SERVICE BULLETIN

FIELD CAMPAIGN SERVICE BULLETIN #: SVC2022-071

<p>PRODUCT SAFETY RECALL</p> <p>SECOND NOTICE</p>
---	---

BC1200XL Wheel and Tire Assembly Replacement Kit (IK00-3973)

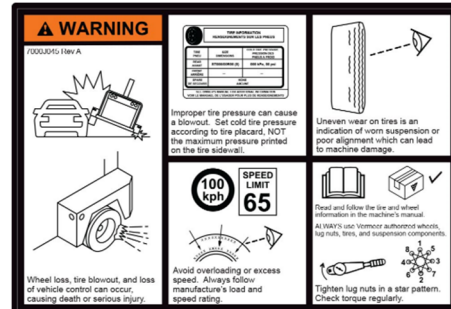
IK00-3973 contains a new safety sign (shown to the right) and updated Operator’s Manual and Maintenance Manuals. No wheel/tire assembly is included in IK03- or IK04-3973. See sample owner letter #1 at end of this Bulletin. **This kit must be installed as soon as possible.**
